Piper Aircraft, Inc.
2926 Piper Drive
Vero Beach, FL, U.S.A. 32960

SERVICE NO. 1318B BULLETIN

FUSELAGE STATION 144.25 RIVET REPLACEMENT

PA-46-600TP M600

POH VB-2366 Temporary Page

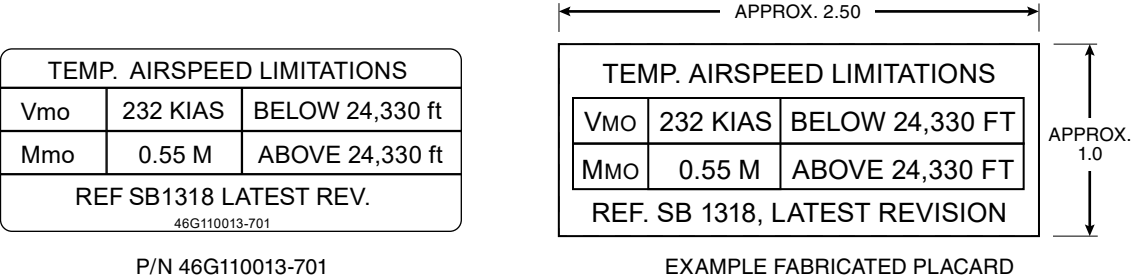
1. RC – Cut out and **insert the temporary page from Figure 1** into the current PA-46-600TP Pilot's Operating Handbook (POH) VB-2366, after the existing page 2-2.

NOTE: SB 1318B, Figure 1, is the same as SB 1318A, Figure 1, "POH VB-2366 Temporary Page." Both are acceptable for use in compliance with Part I of this service bulletin.

Figure 2
P/N 46G110013-701 and an Example of a Fabricated Temporary Placard

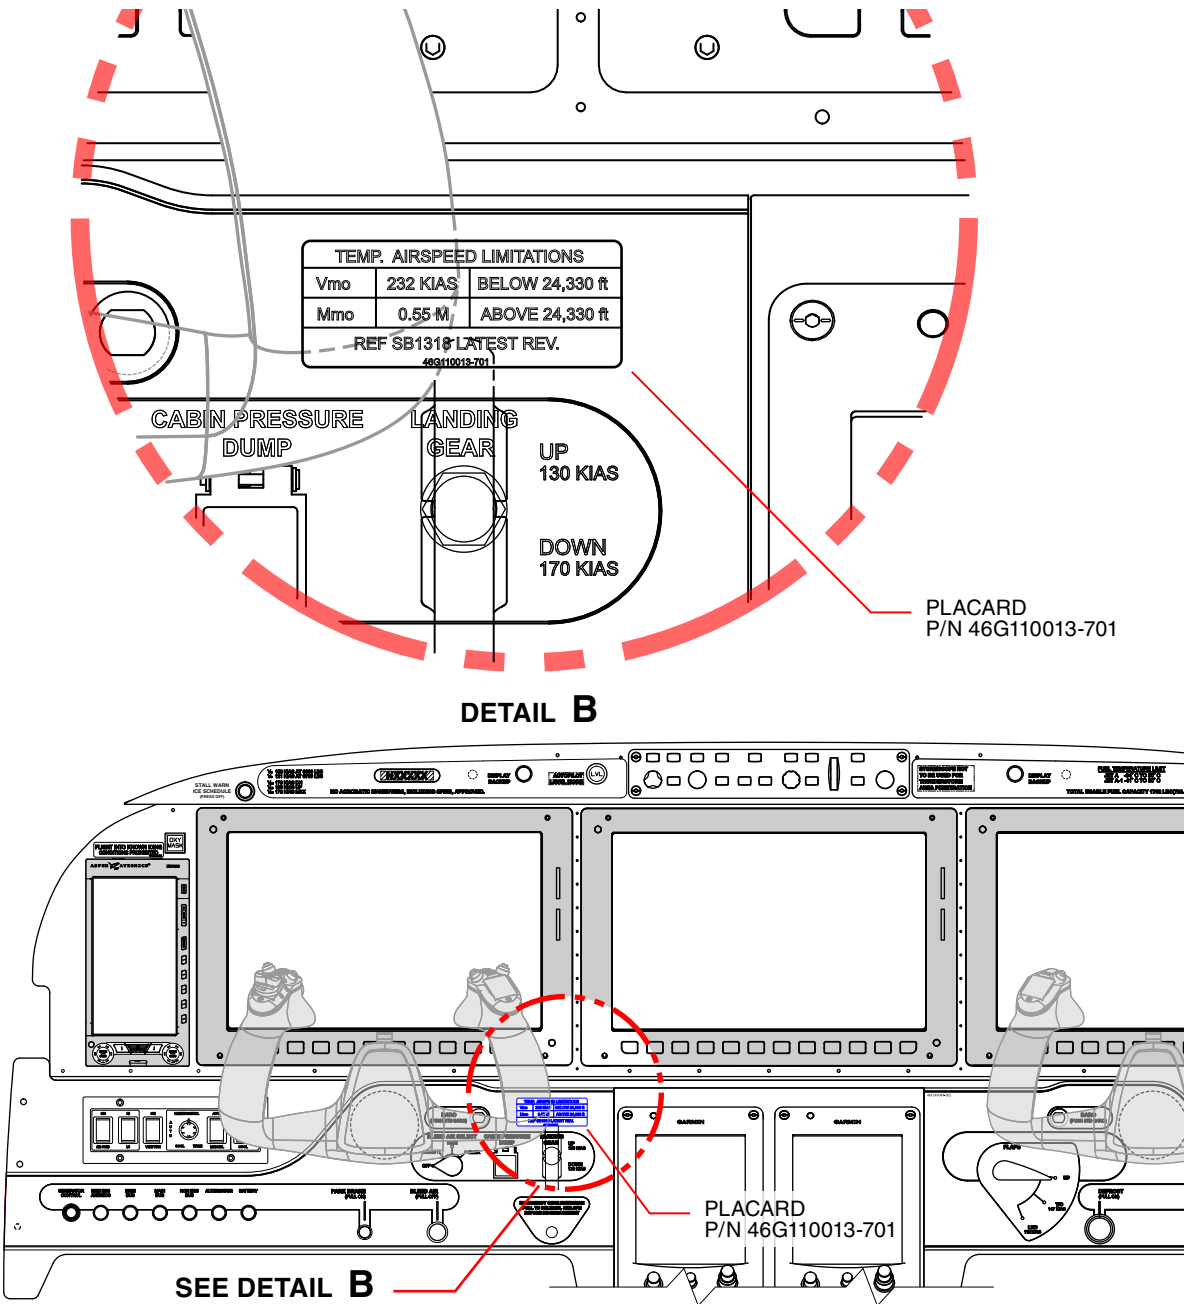
Alternatively, it is permissible to either 1) fabricate a placard or 2) utilize one of the placards in Figure 2:

- The size of the placard shall be no greater than one (1) inch high by 2.75 inches wide (1 x 2 3/4).
- The layout of the text shall agree with the example fabricated placard in Figure 2.
- The colors used shall be either white text on a matte black background, or black text on a white background.
- The font size shall be nine points (9 pt.) or larger.
- The text shall be comprised of all upper case (capital) letters.
- The typeface shall be chosen for its legibility. Examples include Alternate Gothic #2, Arial, Calibri, and Helvetica.

- 2) Print and cut out either of the example placards from Figure 2. Print the placard at the actual size.

- b. Install the placard onto the cockpit instrument panel in the location shown in Figure 3.

Figure 4
Canopy Rivet Inspection

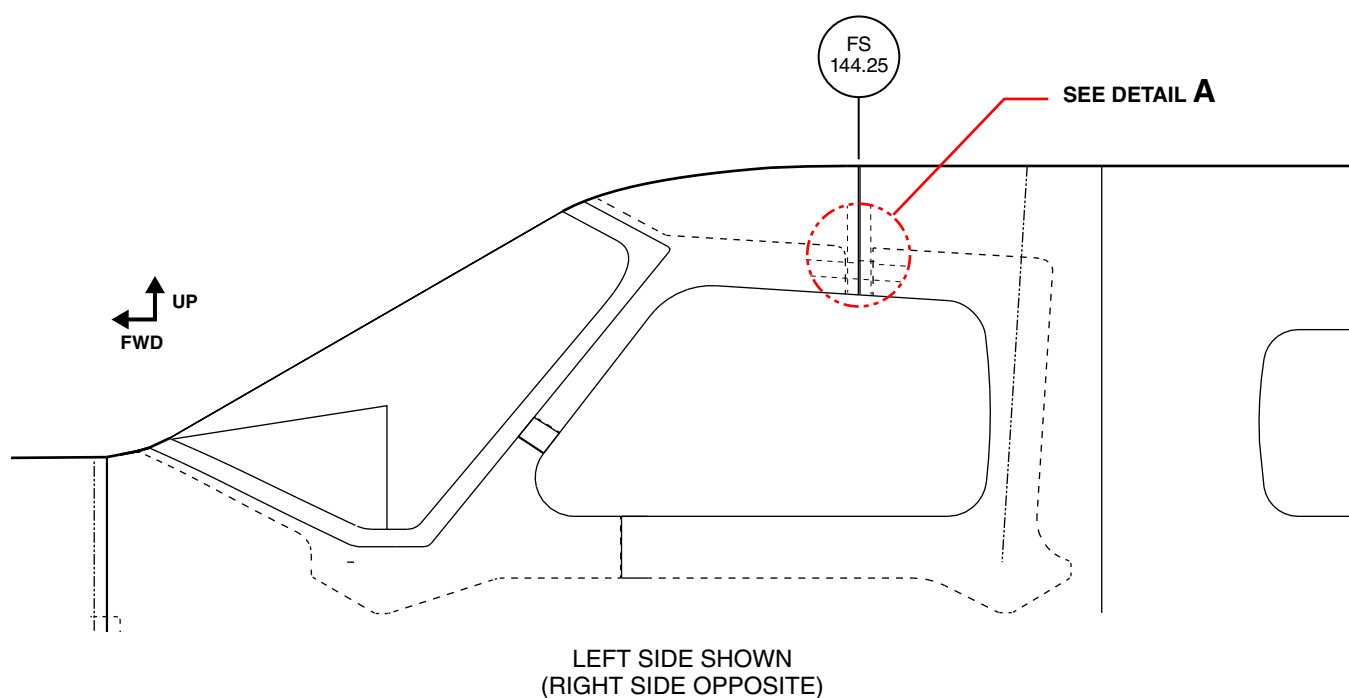
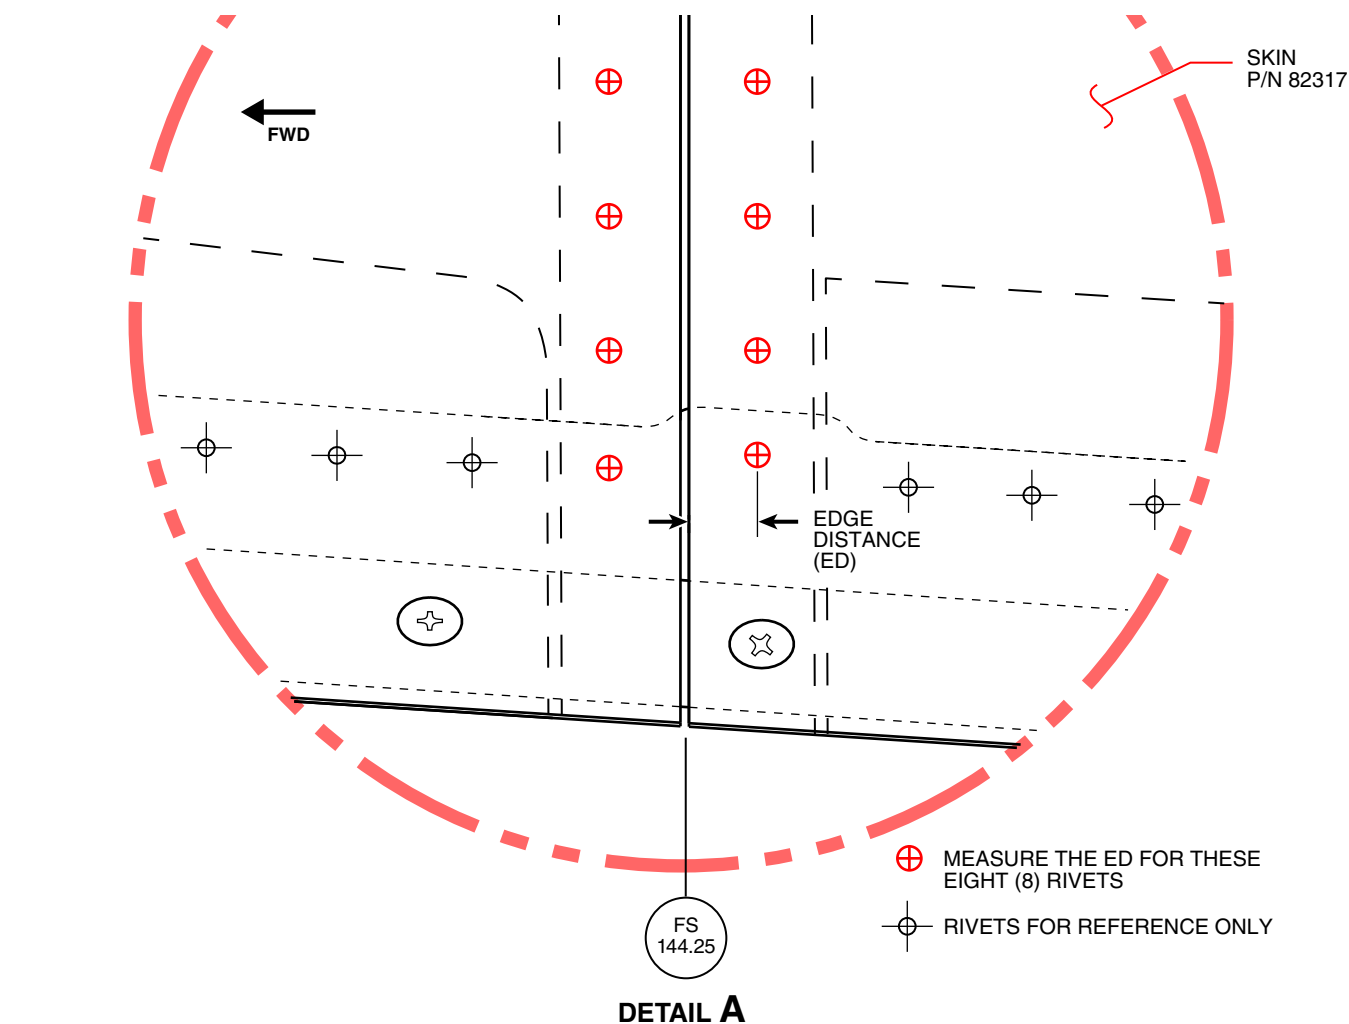
1. RC – Locate the canopy area above both cockpit side windows, which is shown in Figure 4, Detail A.
2. RC – The topcoat of paint will likely obscure the rivet pattern shown. If necessary, locally remove paint to the depth required to gain visual access to the rivet heads. The removal of paint to the bare metal is not required.
3. RC – At each of the eight (8) rivets specified, per side: measure the edge distance (ED) from the center of the rivet to the edge of the skin, as shown in Figure 4, Detail A.

- **If the ED for each rivet** meets or exceeds 0.30 inches, only the replacement of the rivets is required. Order and install Rivet Replacement Kit, Piper Part Number (P/N) 88623-701, Revision A.
- **If the ED for any of the rivets** is less than 0.30 inches, modification to the airframe and rivet replacement is required. Order and install Canopy Modification Kit, Piper P/N 88624-701, Revision A.
